CENTRAL Registry (120-5-18-9) SG Building Construction - Working project - General Assembly of North parking - 1/2 -
Fuller-Turner-Walsh-Slattey, Inc.

FULLER - TURNER - WALSH - SLATTERY, INC.
UNITED NATIONS CONTRACT
403 EAST 42ND STREET
NEW YORK 17, N. Y.

Re: Contract HQ 1/82 - General Assembly & North Parking Space
CHANGE NO. 192 - Revisions to Plumbing Work Originating
in the Field

2 Sheet 4 29May'51 Method of Anchoring Parapet between Cols. O' & I'
27-25

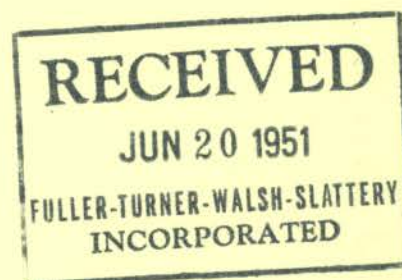
(APPROVED AS NOTED 19 June 1951 FB/GEA RESUBMIT)

#H. GP. 49-4 Date 6/12/51

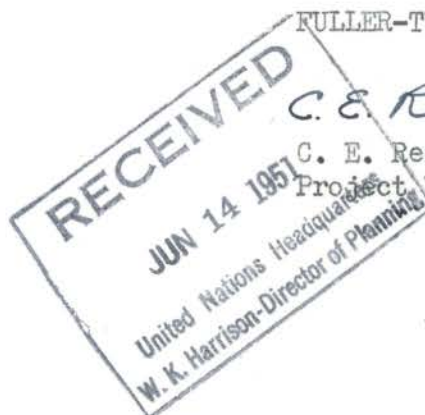
(APPROVED AS NOTED 20 June 1951 V.R. RESUBMIT)

2	GBA-31	20Apr'51	Scale Details Alum. Panels - Stair #36, Escalator
2	32	"	Alum. Side Panels & Soffit Grills Stair 36, Escalator
2	33	"	Alum. Panels - Stair 36 - Escalator

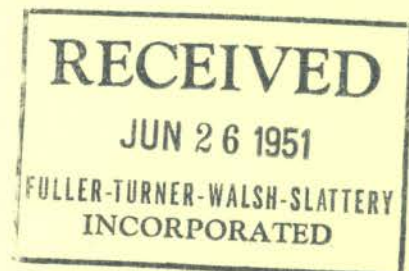
(APPROVED AS NOTED 25 June 1951 P.B per Y.L. RESUBMIT)
